VTS Remote Services Fail due to False 3G

Vehicles Affected

Figure 2

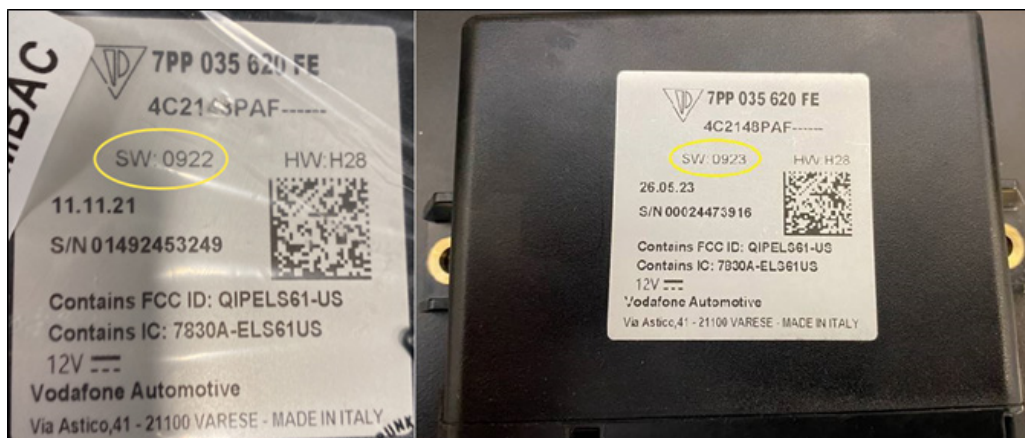
If you receive this part with a software version lower than 0924, please submit a Parts Claims and Returns PRMS ticket to your Area Parts Support Specialist for further instructions. (See figure 2 for 'bad' part examples.)

The workshop must replace the PCC/PVTS control unit to fix this condition. The desired part number is 958.035.620.J. The ECU label should show software version 0924. (See figure 1. This is a 'good' part.)
